REQUEST FOR INFORMATION **DATE:** February 21, 2017 **NO.:** RFI-451

Project Name: 15051-Webster University Interdisciplinary Science Building Project No.: 15051

Subject: Beam Conflict With Shades

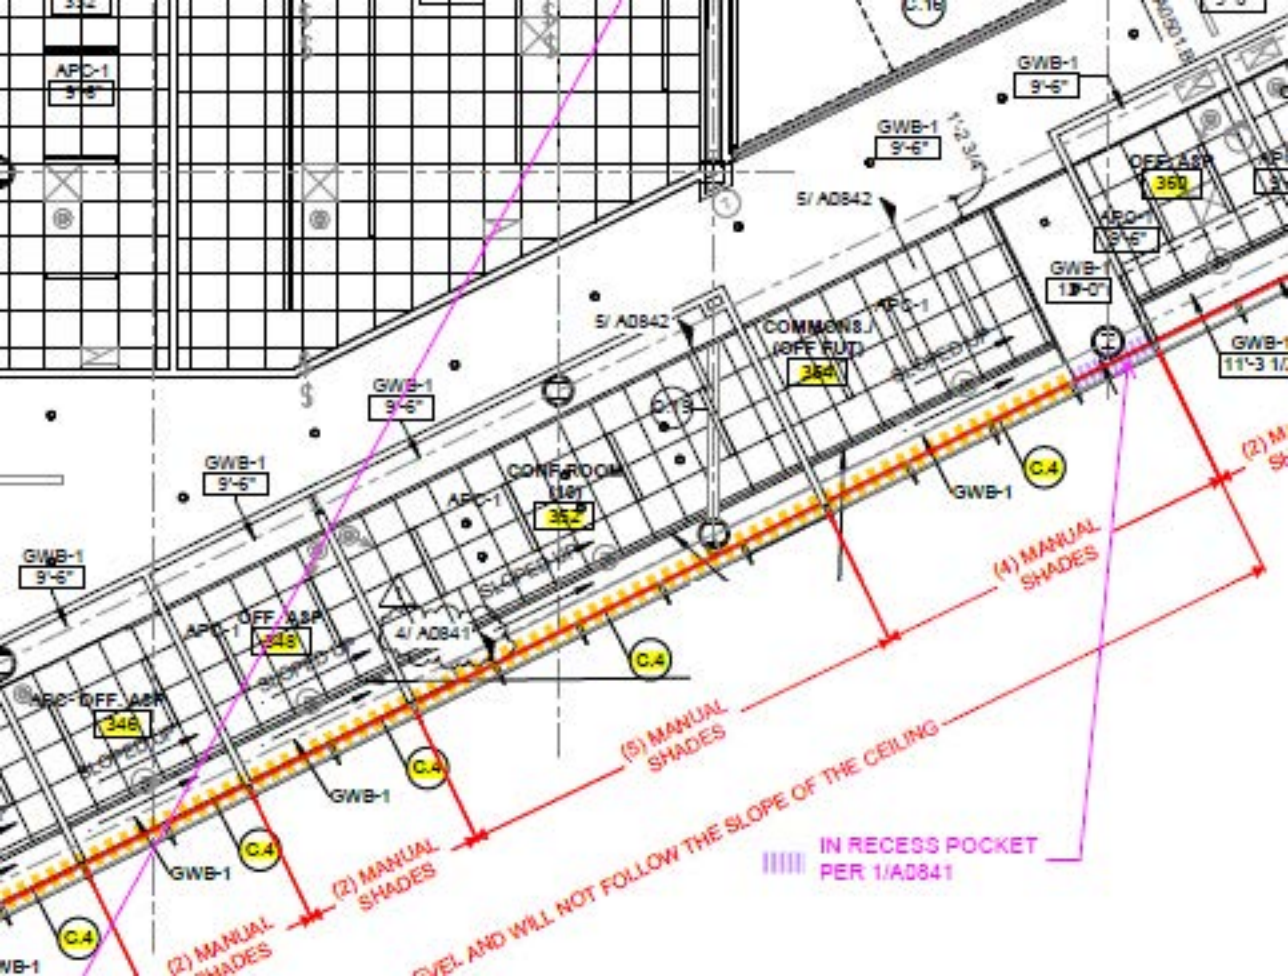
The roller shades cannot be installed per design due to exposed steel in the commons rooms (354/356) as well as in offices 313, 315, 317, and 319.

See attached photos. I recommend a field walk after the upcoming OAC meeting.

REFER TO RFI-447 RESPONSE.

SHADES ARE SUPPLIED
AND MOUNTED TO STEEL
ANGLE SPANNING
ACROSS ROOM.

THESE SHADES WILL BE INSTALLED LEVEL AND WILL NOT FOLLOW THE SLOPE OF THE CEILING
